Work Order ID 88742

Item Name: Replacement Skidtube

| DRAWING NO. D3274 | TITLE SKIDTUBE ASSEMBLY | REV. D | DART AEROSPACE USA, INC ENGINEERING ORDER | D.E.O. NO. D3274-D-1 | SHEET NO. SHEET 1 OF 1 | SCALE NTS |

DETAIL F: END FINISHING DETAIL

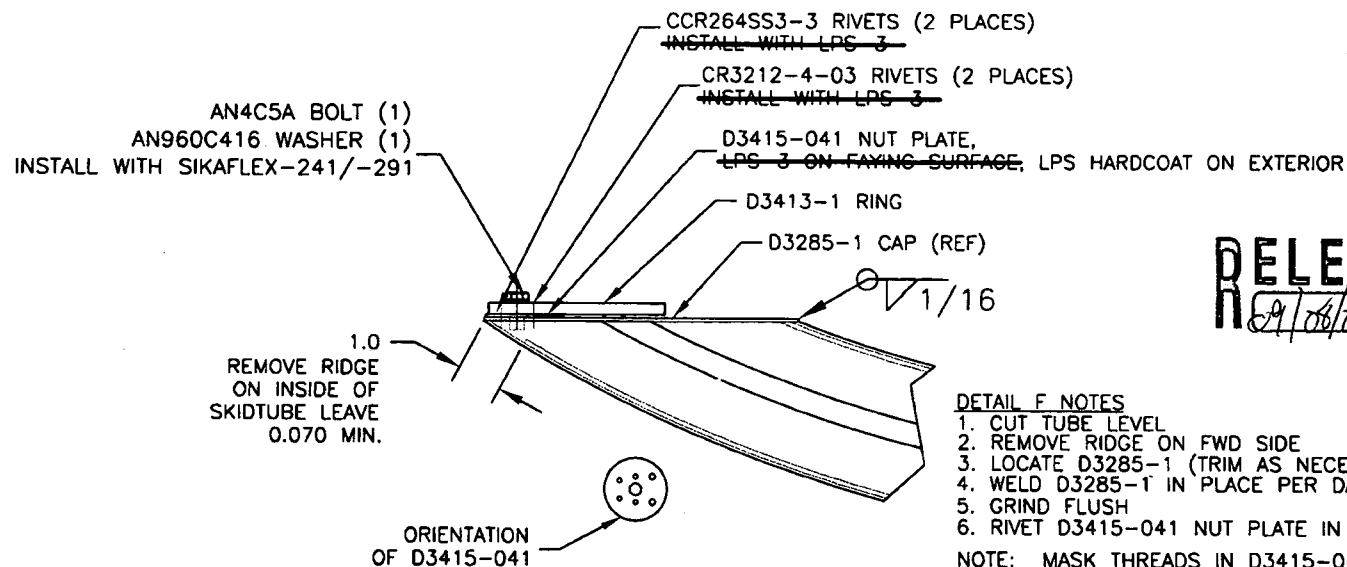
LPS-3 IS NO LONGER USED DURING ASSEMBLY OF SKIDTUBE.

AMEND NOTE 8: ~~"SPRAY INSIDE OF TUBE WITH A COAT OF LPS LABORATORIES 'LPS-3' AFTER FINISH AND INSTALLATION OF INSERTS.~~
COAT ALL EXPOSED FASTENERS WITH LPS LABORATORIES 'LPS PROCYON' AFTER FINAL ASSEMBLY, CLEAN EXCESS OFF
POWDER COATING WITH MEK DEGREASER."

AMEND DETAIL F AS SHOWN:

1. CUT TUBE LEVEL
2. REMOVE RIDGE ON FWD SIDE
3. LOCATE D3285-1 (TRIM AS NECESSARY)
4. WELD D3285-1 IN PLACE PER DART QSI 004
5. GRIND FLUSH
6. RIVET D3415-041 NUT PLATE IN PLACE
